No. 1 - REQUEST FOR REVIEW: LA21057 / Tateson Ranching Ltd.

Re: Decision LA21057 – Request Board Review of Permit Conditions
Julie and Scott Tateson, Tateson Ranching Ltd.

Application LA21057: Feedlot application to construct a 3000 hd beef finisher feedlot operation with 4 rows of pens and a catch basin. The application also notes cow-calf pens which are located beside the feedlot and are intended to be used for Tateson's breeding herd only. The cow-calf portion of their operation is considered a season feeding and bedding site (SFBS).

Attachment Figure 1 – Cow-calf pen west fence and berm height (looking west)

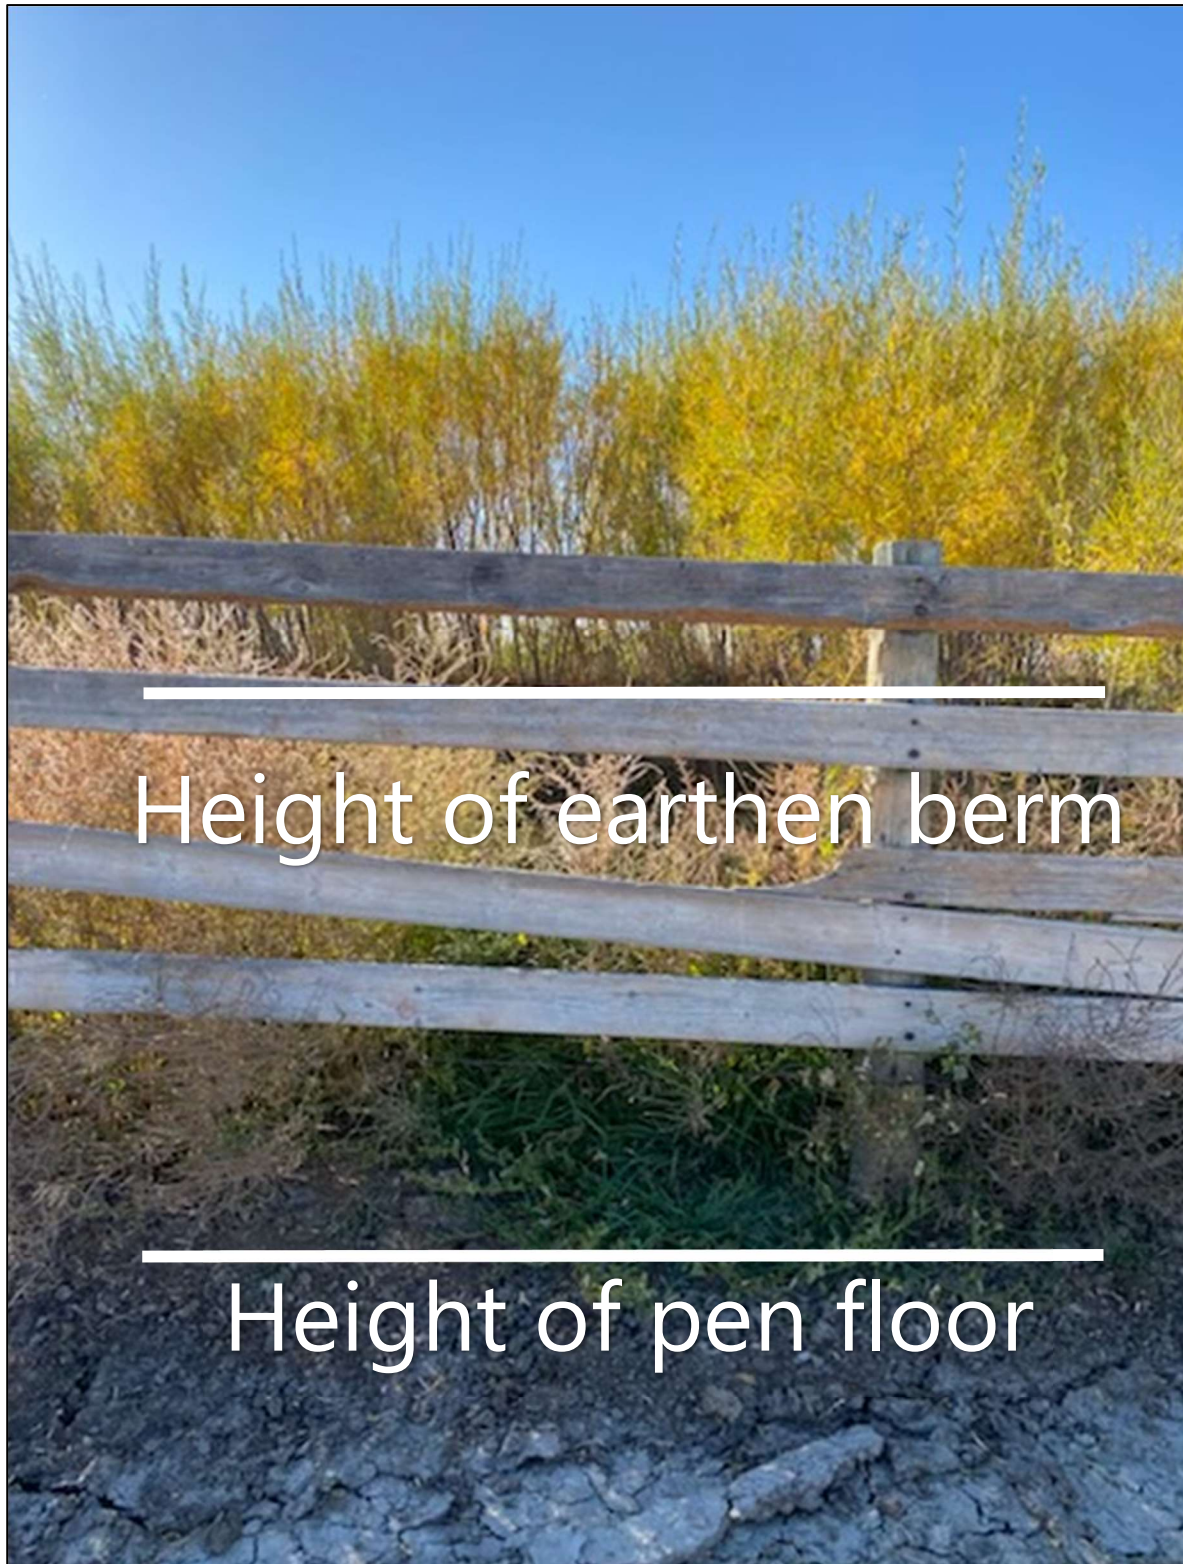
Decommissioning - The condition states: *The co-permit holders shall decommission any parts of the constructed feedlot pens (including fences, bunks, etc.) that are closer than 30 m to the irrigation drain.*

The Standards and Administration Regulation (the Standards) section 7(1)(c) states that a manure storage must be 30 m setback to a common body of water. However, under 7(3) Subsection (1)(c) the setback does not apply if the owner or operator demonstrates to an approval officer or the Board, before the facility or area is constructed, that; (a) the natural drainage from the facility or area is away from the common body of water, or (b) a berm or other secondary protection for the common body of water constructed by the owner or operator protects the common body of water from contamination.

The AO was provided with application information that suggests the feedlot would be constructed with drainage to the east (which would flow away from the common body of water) and written confirmation that the irrigation ditch (drain) was constructed in such a way that the SFBS and feedlot runoff could not enter the ditch (see Aug 8, 2022 email correspondence below).

In additions, Figure 1 (below) illustrates the difference in elevation between the top of the earthen berm and the SFBS pens. The berm extends along the length of the cow-calf site and feedlot.

Attachment Figure 2 – Site map with low area (white square) for pen runoff for cow-calf pens

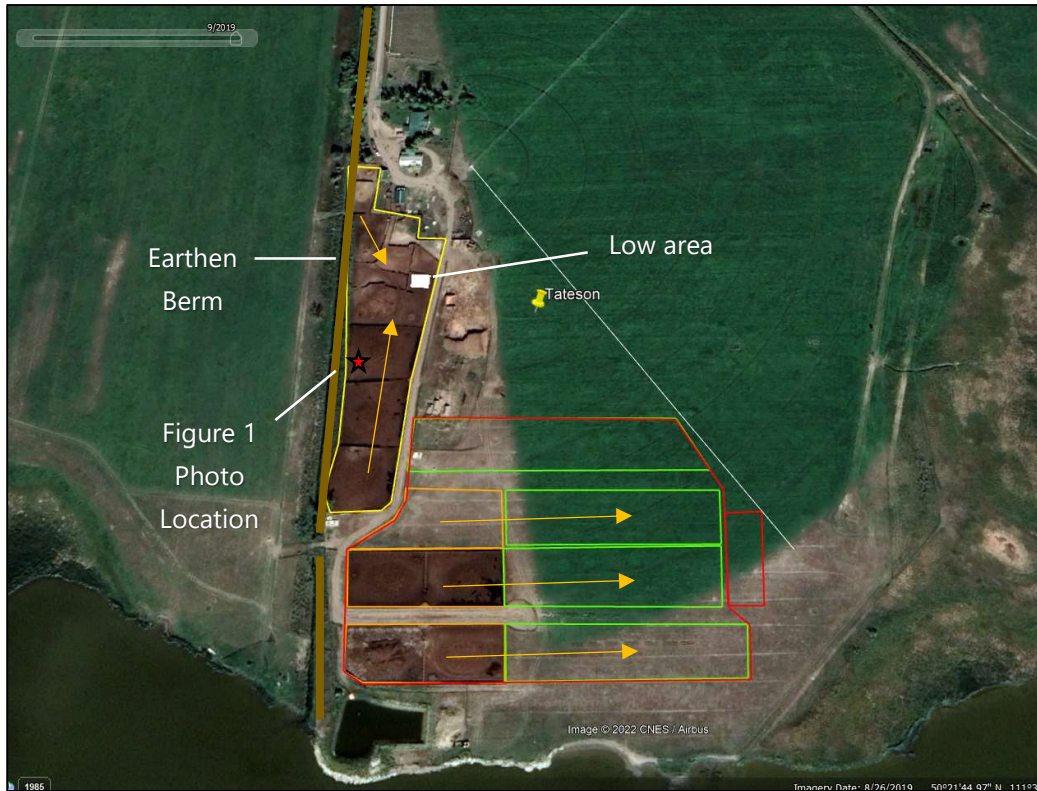
Runoff control plan for the cow/calf site – The condition states: *The co-permit holders shall submit a detailed plan showing how manure contaminated runoff will be prevented from leaving the cow-calf site (as shown on page 5 of Technical Document LA21057), and how manure from this site will be managed.*

- 1) The SFBS meets the Standards section 4(2)(a), which required the presence of an intercept (berm) between the site or corral and common body of water which directs water away from the common body of water (as illustrated in Figure 2 below)
- 2) AOPA does not require an operator of a SFBS to develop a runoff control plan
- 3) The AO has not included a risk assessment of the SFBS (which would show how runoff from the SBFS is a risk to the environment).
- 4) The AO did not report AOPA non-compliance or runoff issues resulting from the SFBS. In fact, an NRCB Inspector has been on site, and did not identify any issues with the management of the cow-calf pens.
